To: The Design Advisory Board
From: Ken Lerner *Ken*
RE: 09-181CU/CA 21 Ledge Road
Date: May 10, 2011

File: 09-181CU/CA
Location: 21 Ledge Road
Zone: RL **Ward:** 6
Date application material received: April 26, 2011 (note application incomplete until required fee paid)
Applicant/ Owner: Mark Gilbert and Theresa Fortner
Request:

Current amendments to ZP#09-181CA: Revised site changes: delete landscaped area & 2 maples, reduce number of arborvitae, add retaining wall, and expand driveway/parking. Reduce addition and size of deck. Change windows.

Regarding: Zoning Permit #09-181CA Record Drawing Submission – Response to Staff
Comments

Photo #1 – Existing maple trees and Corner stake for adjacent property

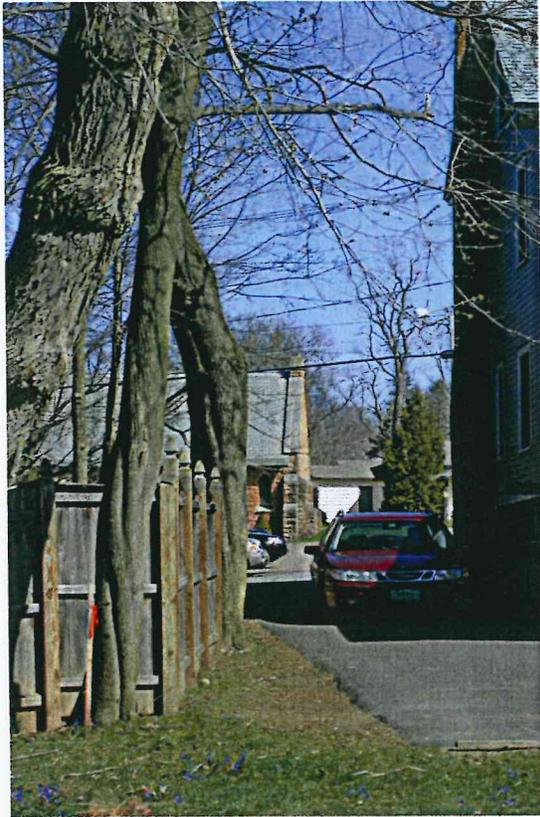
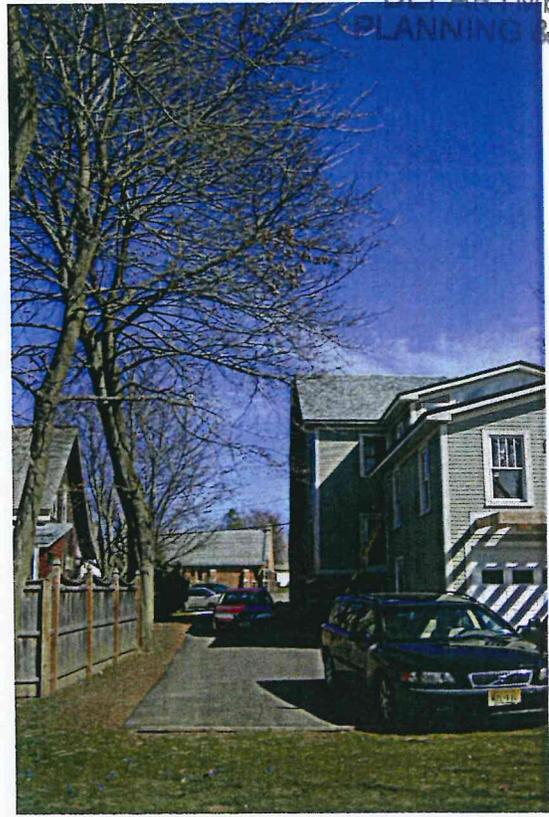
Staff Comment #1 - Different species and fewer trees. The two red maple trees as per the original are to be planted.

Owner Response - It is unclear if the staff is asking that the two trees planted and reflected on the record documents (one 2 ½" linden and one 2 ½" crab apple) are to be changed to red maples as originally intended or if the staff is asking that the two red maples originally intended as shade trees (of which we have planted one, 2 ½" linden) for the parking area be planted. In response:

1. A linden (equivalent caliper as originally proposed) was planted in lieu of a red maple at the south east corner of the parking area because the nursery suggested this was a better tree for the soil type. Mary O'Neil stated this was an acceptable change when we met with her and reviewed this on 3/11/11.

2. The red maple in the southwest corner of the parking area was omitted because a large (15") maple already exists, within the same proximity to the parking area. It was undetermined if this tree (and an adjacent, larger tree) were on our property at the time of the original submission. A subsequent survey (necessary to determine boundary lines due to existing fence location) confirmed these trees are on our property. It makes no sense to plant a small tree under the canopy of this much larger, healthy tree, which (in conjunction with a nearby 18" maple) is already shading a good portion of the parking area and driveway. Please refer to attached Photos 1 & 2 and Sketch 1

Photo #3 – Existing parking with "peninsula" sketch in

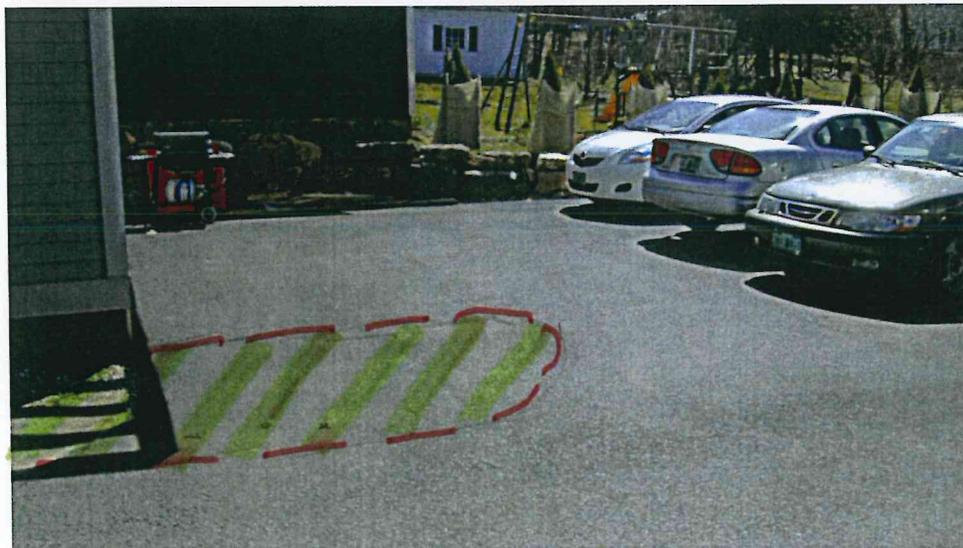
Staff Comment #2 - Original landscaped peninsula deleted. The landscaped peninsula separating the driveway and parking area must be retained as per the original approval. This area was specifically included to break up the now larger paved area in the rear.

Owner Response - This peninsula as originally intended does not function given the parking requirements per the Zoning Ordinance and the narrow nature of the lot. The peninsula would negate any possibility of parking. Please refer to Photos 3 & 4 and Sketch 2 and 3. The overall site coverage, including the requested expansion of the paved area (an additional 180 SF), is within the 35% coverage allowed by the Zoning Ordinance. We could find no reference in the Zoning Ordinance that requires the "break up" of the paved area as suggested in the staff comments nor do we see how this would be feasible on a narrow lot while still providing the required parking. Part of our decision to reduce the size of the building addition was to address the need for changes to the paving and parking configuration while remaining within the 35% coverage requirement.
